National Transportation Safety Board

Safety Recommendation

In reply refer to: A-03-47

This recommendation addresses safety concerns about the simultaneous use of runways 32 and 6L at Ted Stevens Anchorage International Airport (ANC) and is based on operational issues discovered during the Safety Board's investigation of an incident involving an Airbus A-340 that occurred on January 25, 2002.¹ As a result, the Safety Board has issued two safety recommendations to the Federal Aviation Administration (FAA) and one to the management at ANC. Information supporting this recommendation is discussed below. The Safety Board would appreciate a response from you within 90 days addressing the actions you have taken or intend to take to implement our recommendation.

Figure 1. ANC Airport Diagram

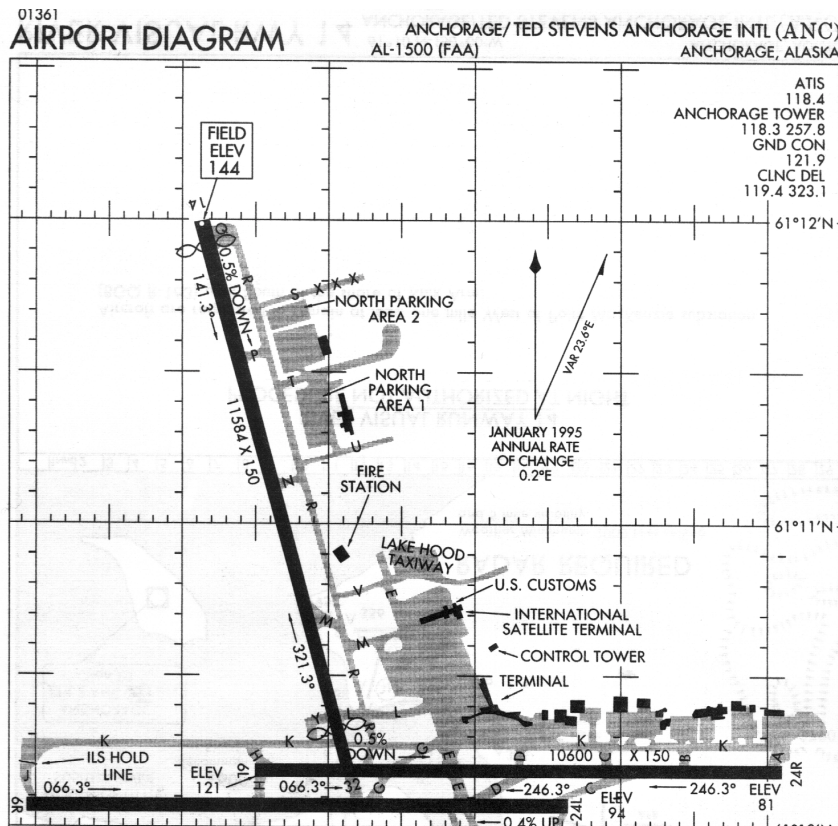
As shown in figure 1, ANC has three runways: 32/14, 6L/24R, and 6R/24L. The end of runway 32 intersects with runway 6L. Flight crews of aircraft departing runway 32 normally depart from the displaced threshold of runway 32 and do not occupy the intersection of runways 32/6L; however, they may use the full runway (known as the runway 32 extension²) by informing ANC tower controllers on initial contact that they wish to do so. These aircraft then

line up with runway 32 and hold in the intersection of runway 32/6L, where they may be required to wait for some time depending on other traffic in the area. Other aircraft may be conducting approaches to runway 6L while runway 32 departures are holding at the intersection.

According to local and regional air traffic staff, the planning stages of the runway 32 extension project at ANC included discussions about changing the airport's design to preclude holding aircraft on runway 32 and 6L. Among the alternatives considered were an extension of runway 32 and associated taxiways to a point southeast of runway 6R so that aircraft awaiting departure clearance would be clear of runways 6L and 6R, or an upgrade of the existing blast pad southeast of runway 32 to allow an aircraft to be held between runways 6L and 6R. Because holding aircraft on active runways increases the risk of ground collisions, the Safety Board encourages the use of alternative procedures whenever possible. In the case of ANC, the design of the airport leaves the tower with very limited options in handling full-length departures from runway 32. To remedy this situation, the Safety Board believes that the management of ANC should evaluate, in cooperation with the FAA, the airport's runway and taxiway layout to identify and, if necessary, construct holding areas for runway 32 departures that are clear of runways 6L and 6R.

Evaluate, in cooperation with the Federal Aviation Administration, the runway and taxiway layout of Ted Stevens Anchorage International Airport to identify and, if necessary, construct holding areas for runway 32 departures that are clear of runways 6L and 6R. (A-03-47)
